### **GLWA-SCP-DB-112 Change Order No. 1**

#### **Springwells Water Treatment Plant**

#### **Emergency Grating and Structural Steel Replacement**

**RE:** **Contract No. GLWA-SCP-DB-112 Change Order No. 1**  
***Springwells Water Treatment Plant***  
***Emergency Grating and Structural Steel Replacement***  
**Vendor: Barton Malow**

*Photo 1: Compromised Discharge Header Support*

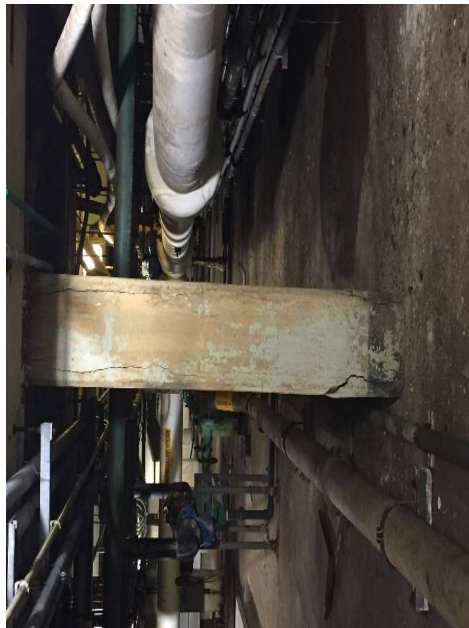
Location F - rehabilitation of discharge header supports. Photo No.1 shows an existing condition where the complete

structural support section has deteriorated to the point that its structural integrity is lost and the support is in need of replacement.
